**Meghan Pump Station (RFCSP)  
Solicitation Number: CO-00645  
Job No.: 19-1006**

**ADDENDUM 2  
October 17, 2023**

10-17-2023 SHEET NO. M3  
21 OF 67

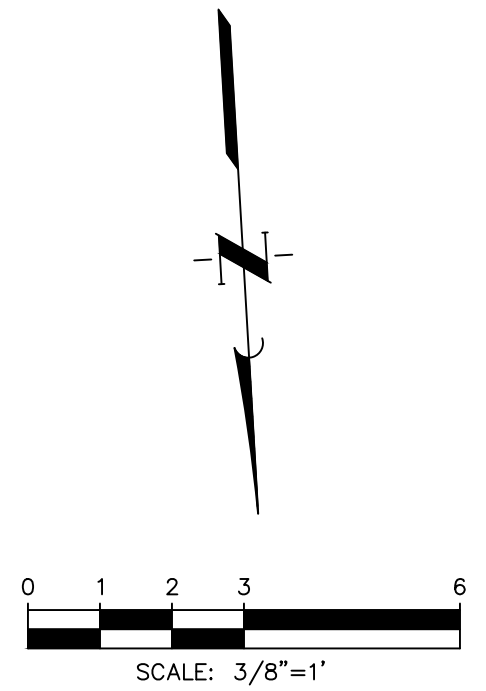
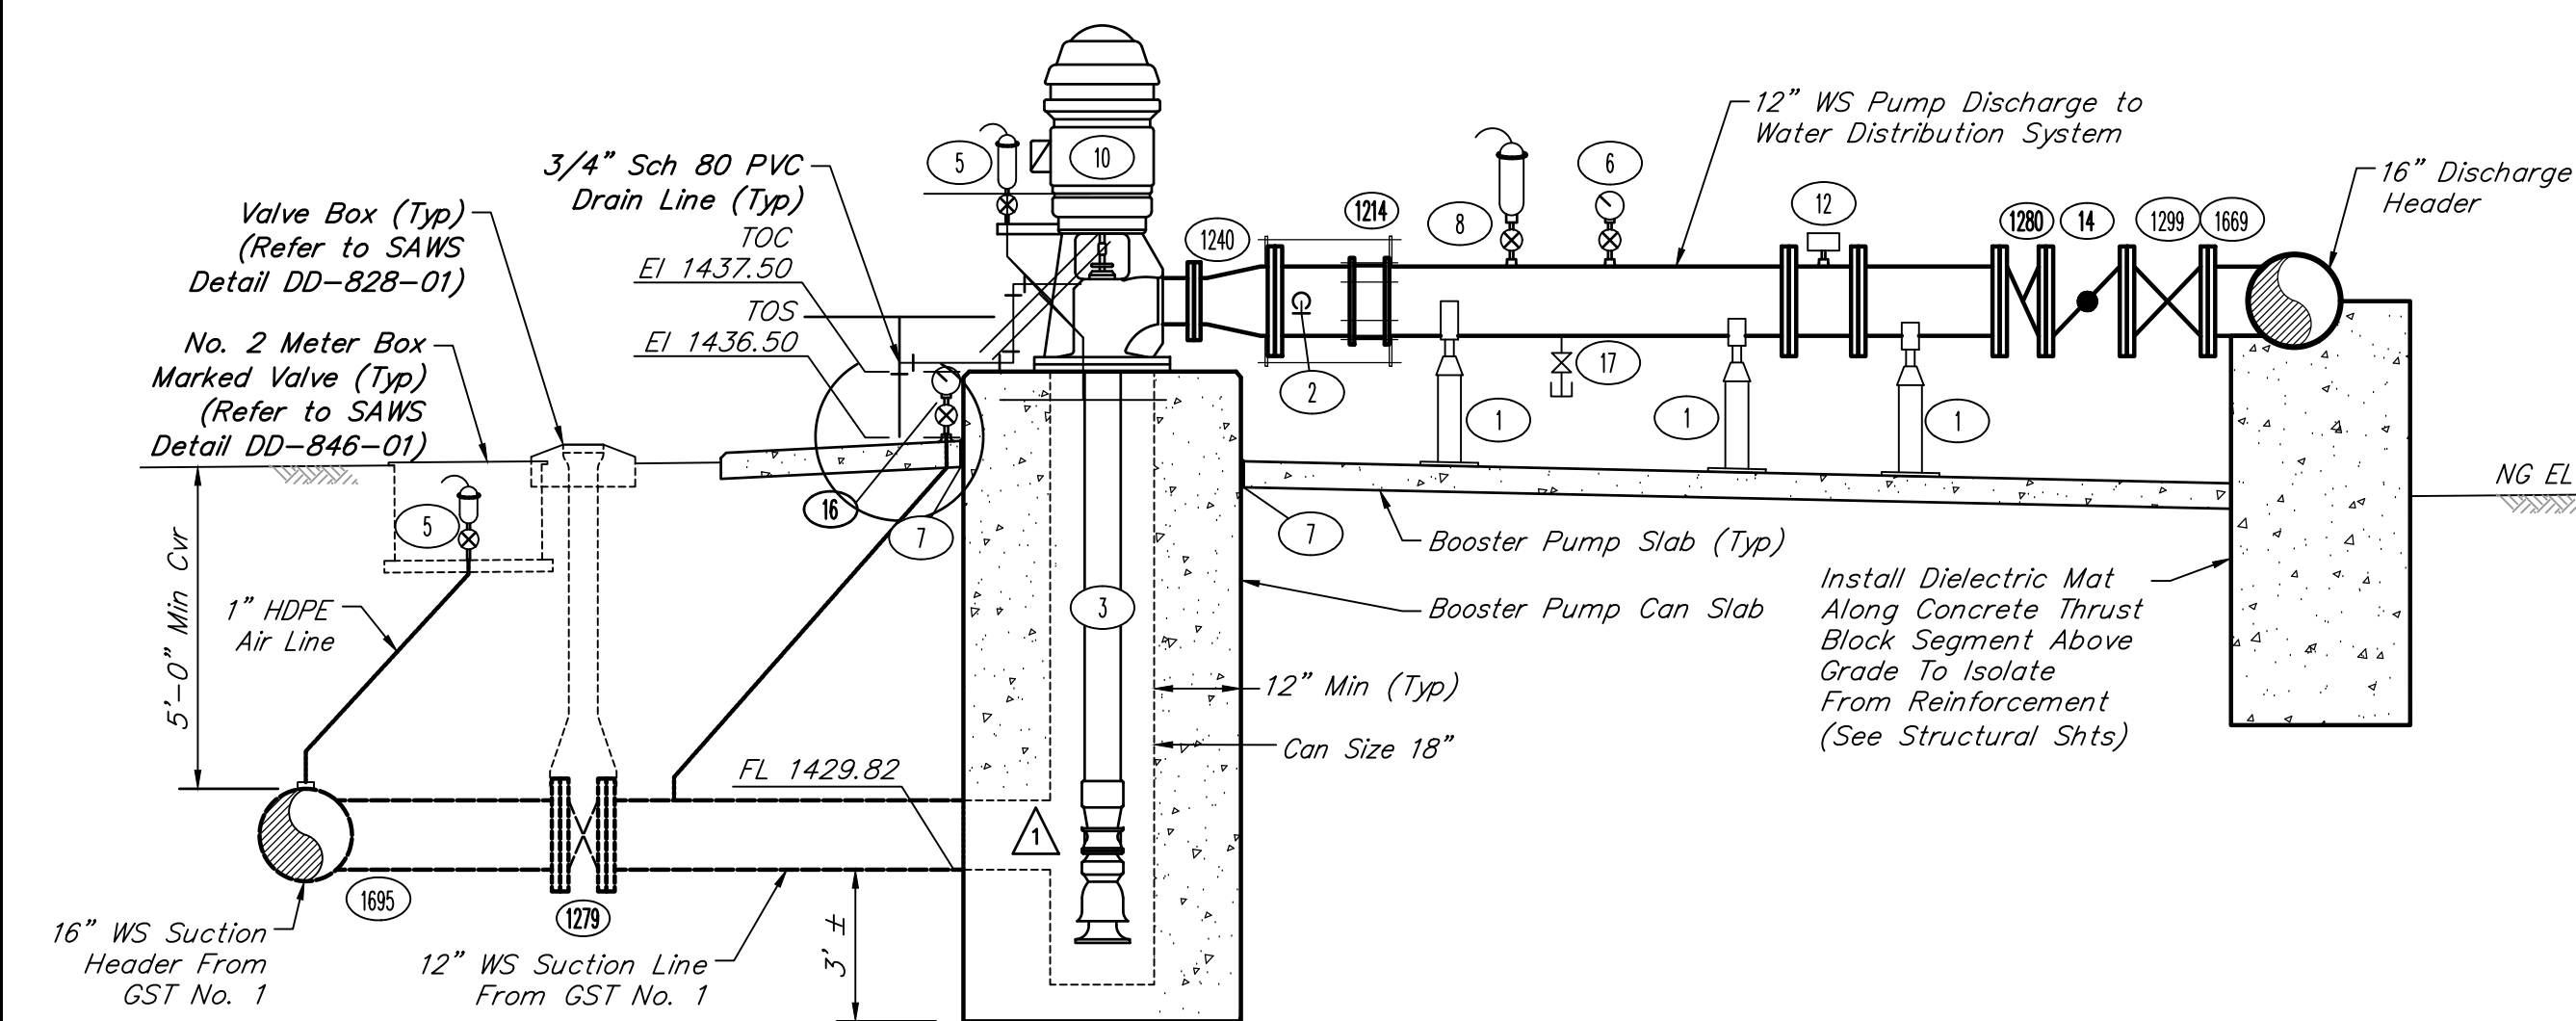
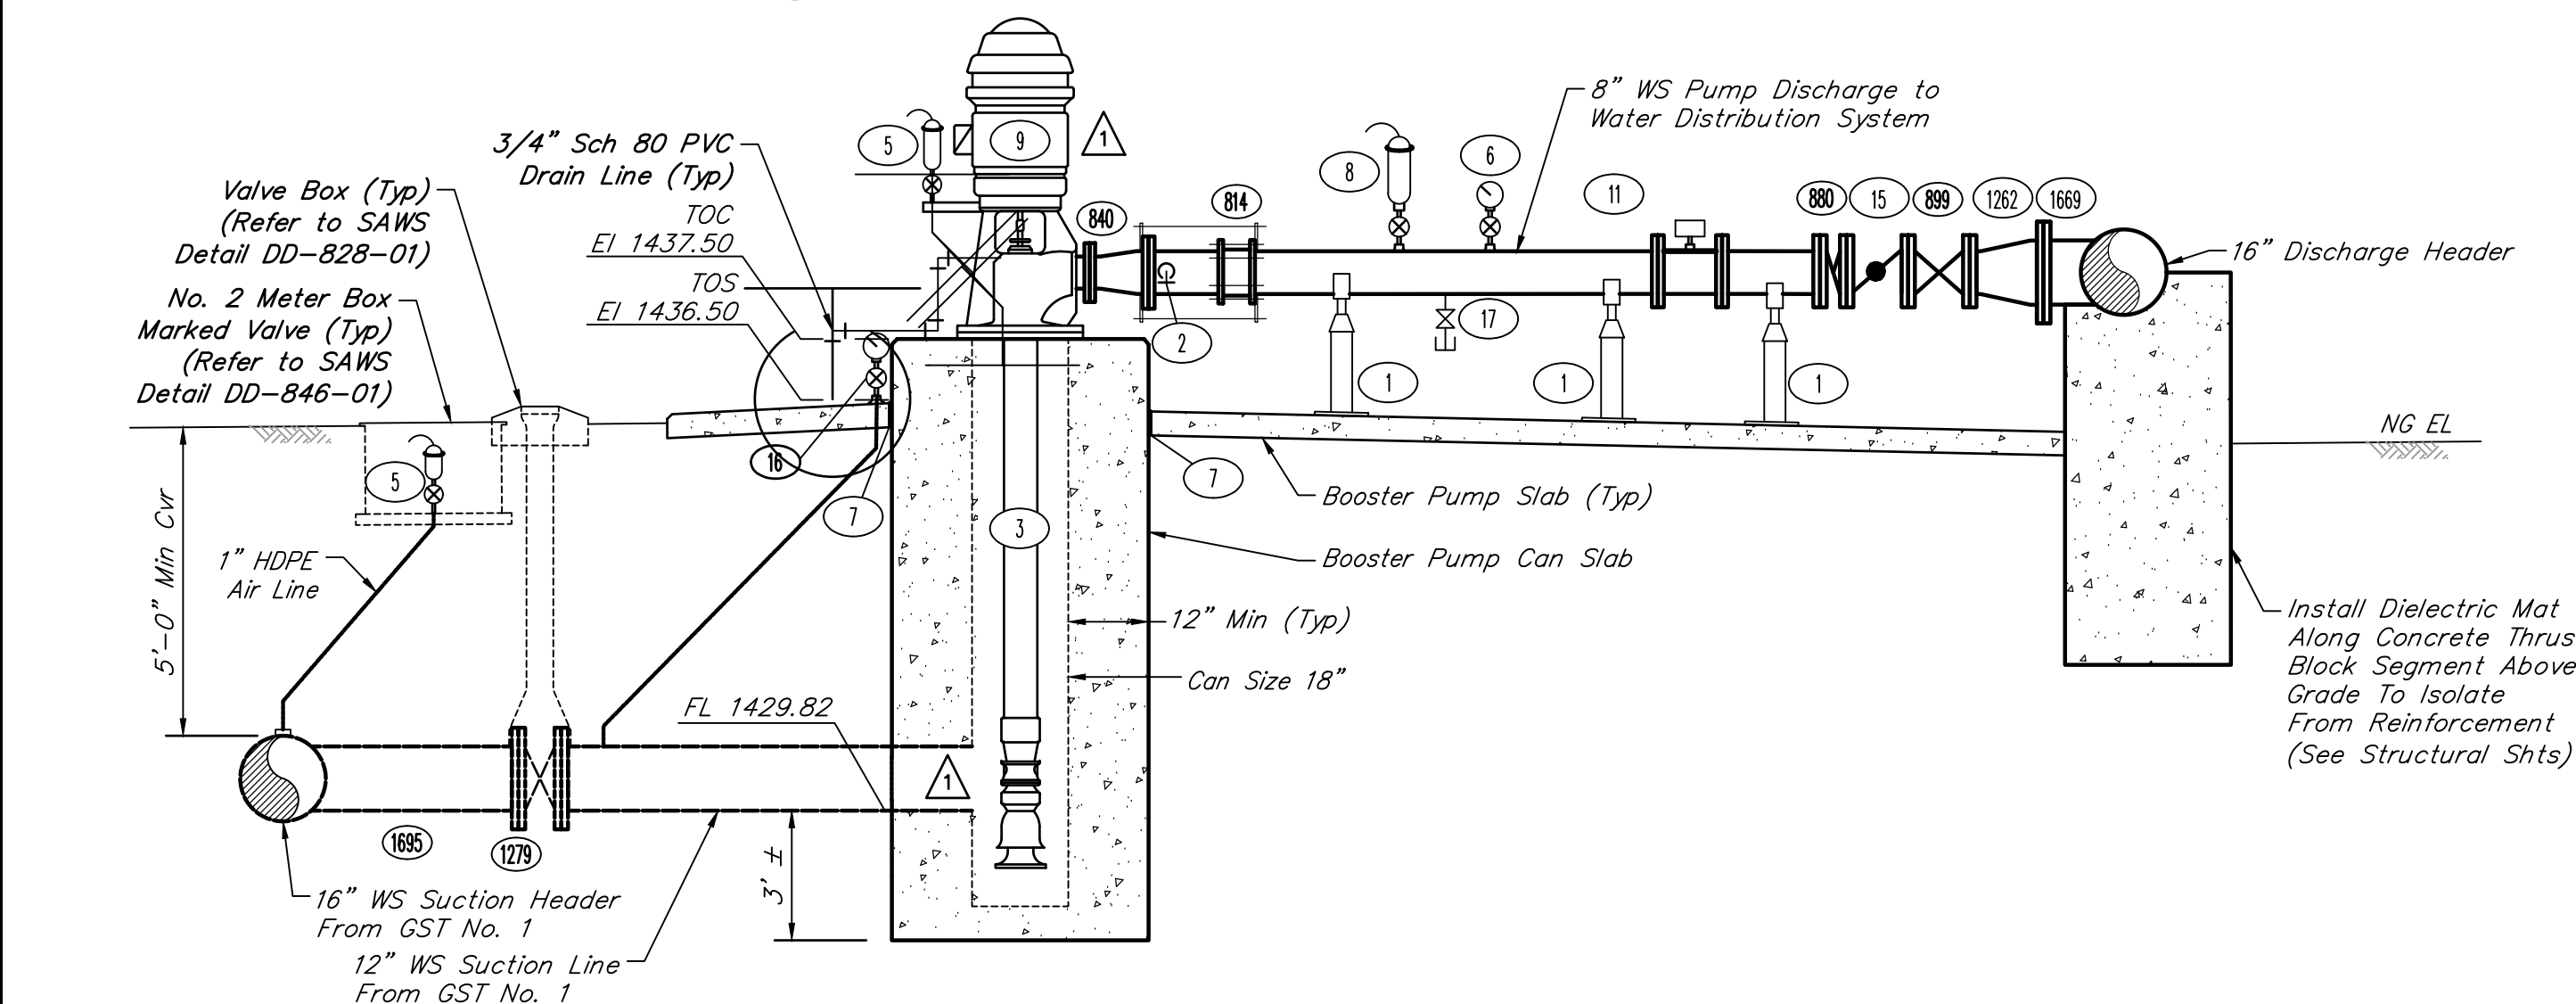
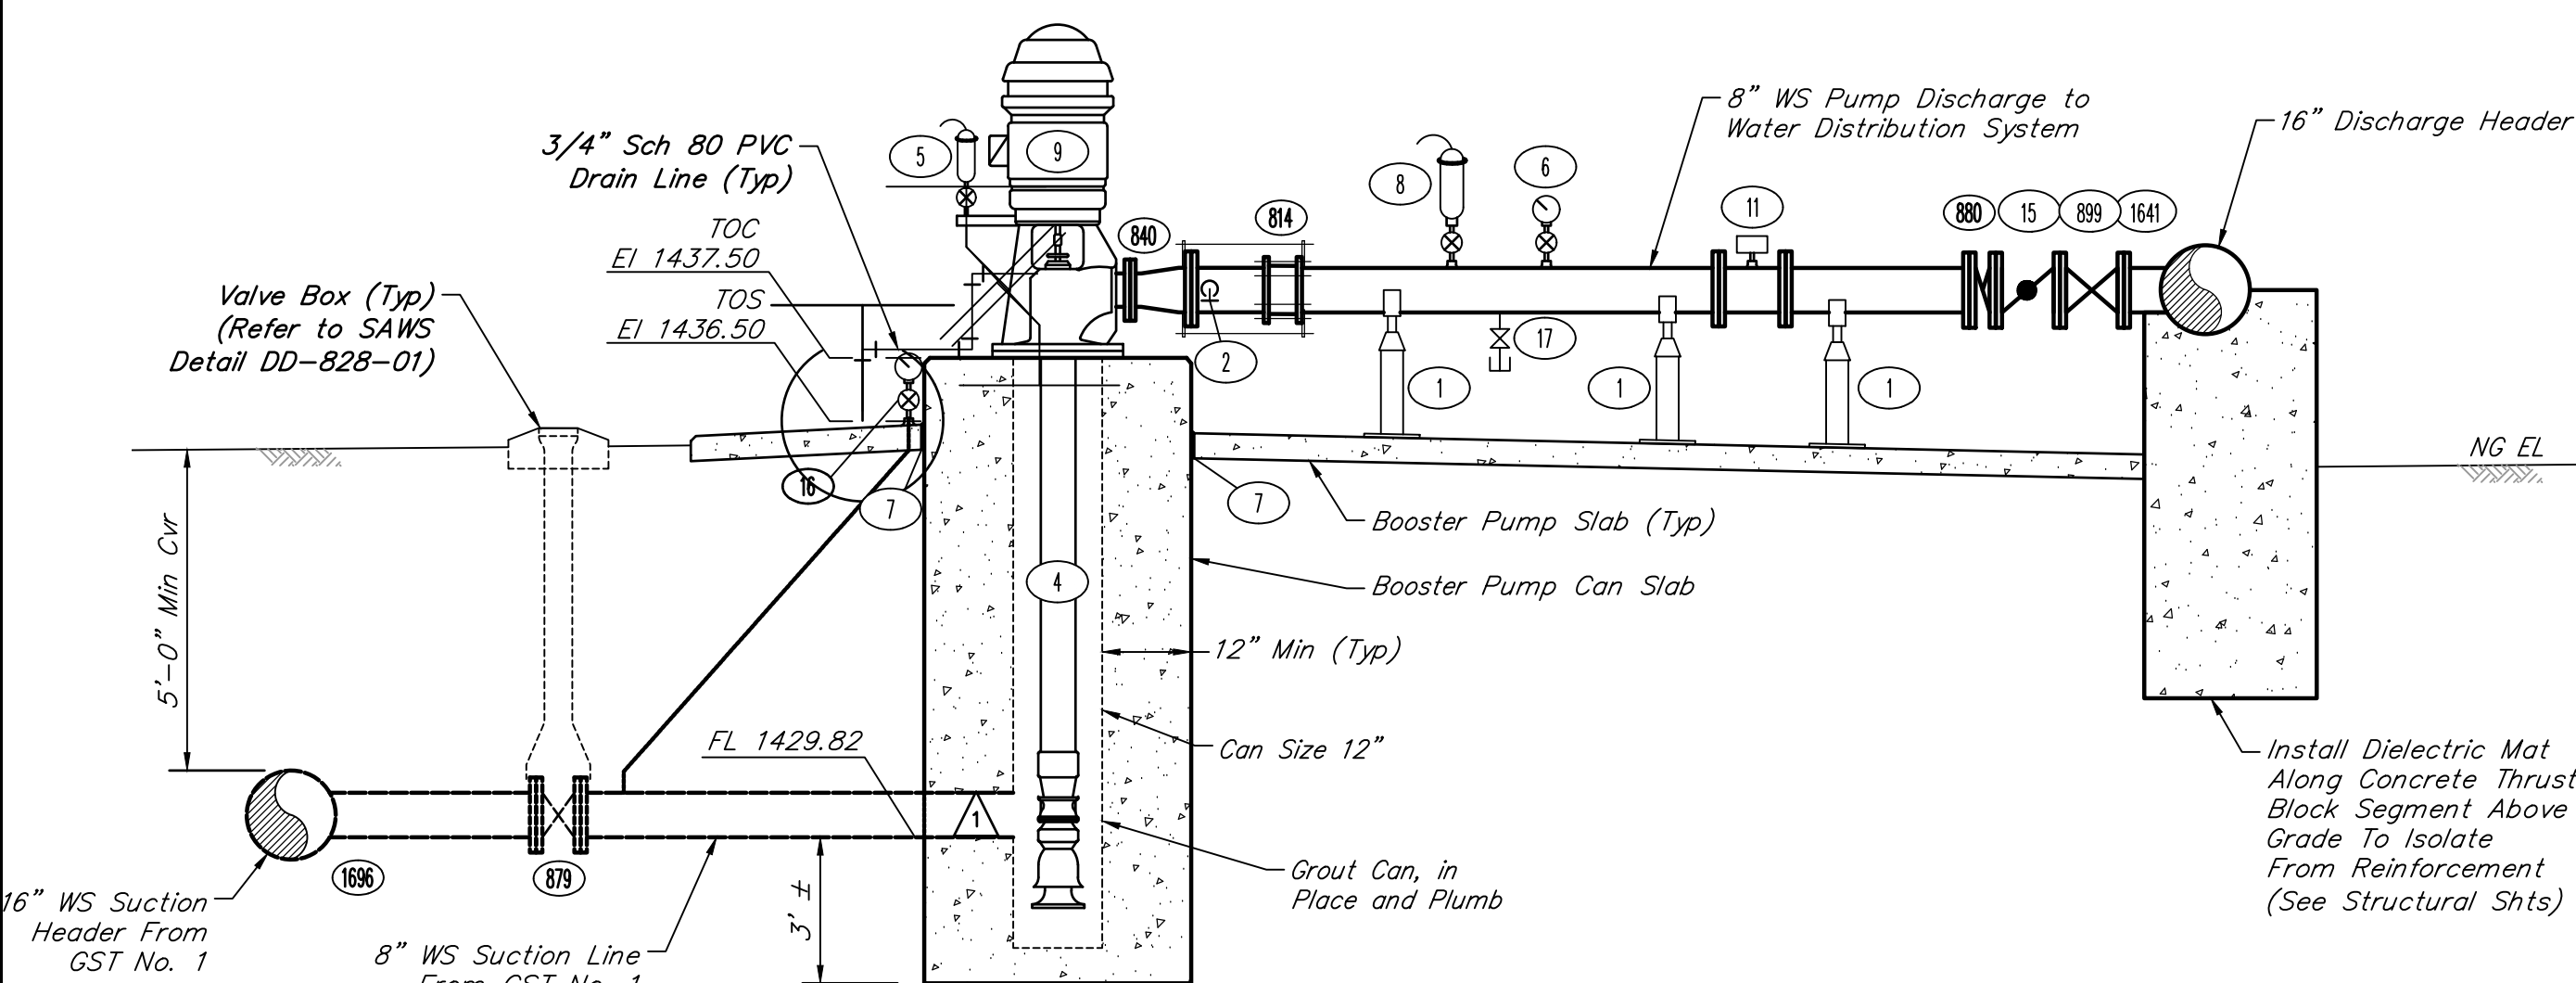
36. **Plan Sheets:** M3: Remove requirement for one-piece galvanized steel pump cans. Pump barrels can be provided with NSF certified epoxy coating. Top flanges need to be welded in field to ensure top flange level tolerance is obtained.

45. On plan sheet M3 the engineer listed two fire PVC lines as 2 ½” C900 DR 18. There is no such pipe. The smallest C900 is 4” diameter. Please reconsider this connection design and what type of connection to use, such as a welded flange (4”) then reduce off the flange to the proper size for the pipe connection.

*Response: See #1 & 2, Changes to the Plans, in this addendum. The indicated revision to has been made to Sheets M3 & M4.*

*Response: See #1, Changes to the Plans, in this addendum. The indicated revision to Sheet M3 has been made.*
